Addendum No.: 1

Date Of Addendum: 12 March 2019

CT DAS | Construction Services | Office of Legal Affairs, Policy, and Procurement
Department of Motor Vehicles
Hamden Roof and HVAC
1985 State Street
Hamden, CT
BI – MM-54

M-400 NOT TO SCALE

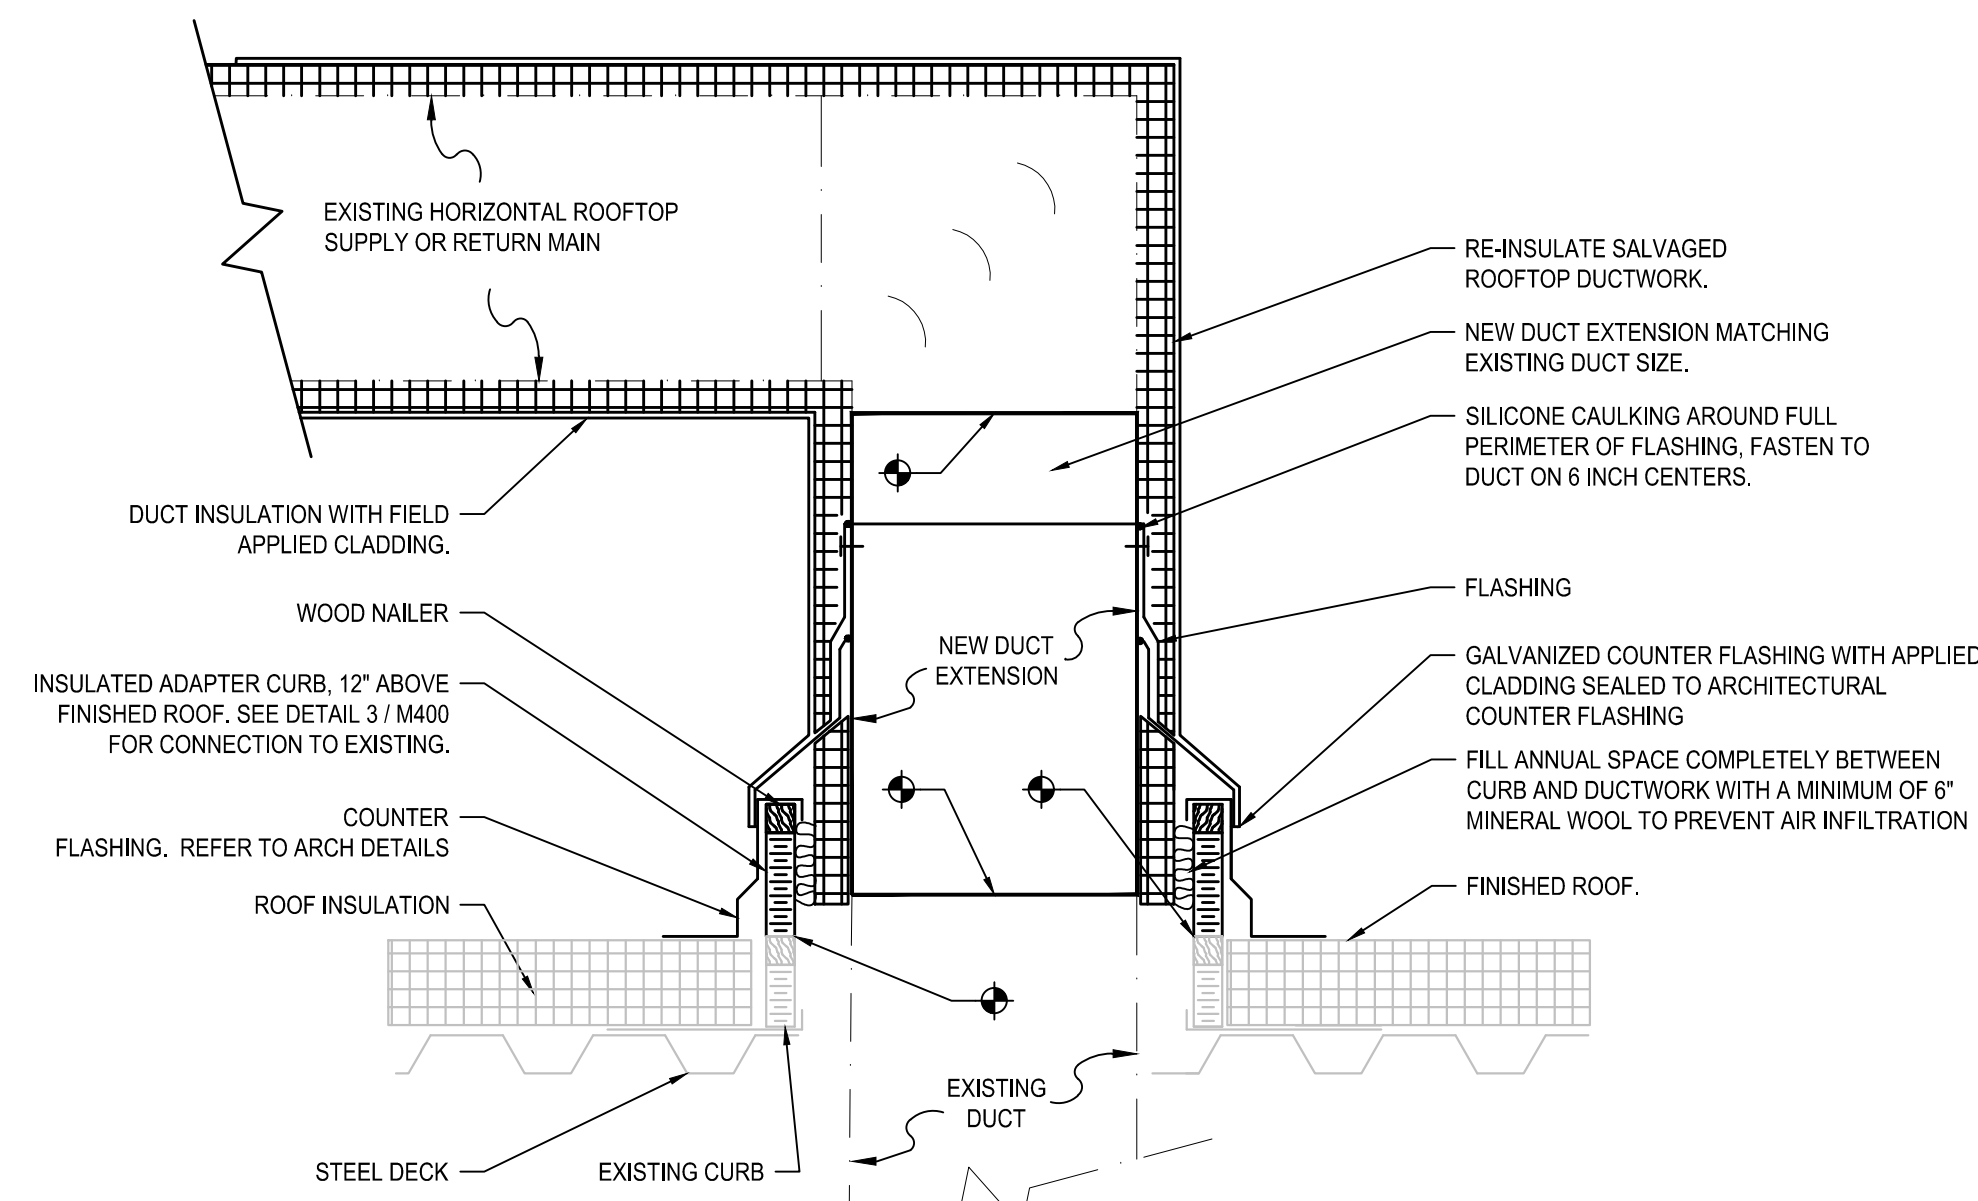
In Drawing M-400 Details – Mechanical:

REVISION: Modify Detail 1/M-400 Modify ductwork support note to include additional manufacture names and model numbers.

SUBSTITUTE: Drawing M-300, dated 03/04/19 Addendum 1
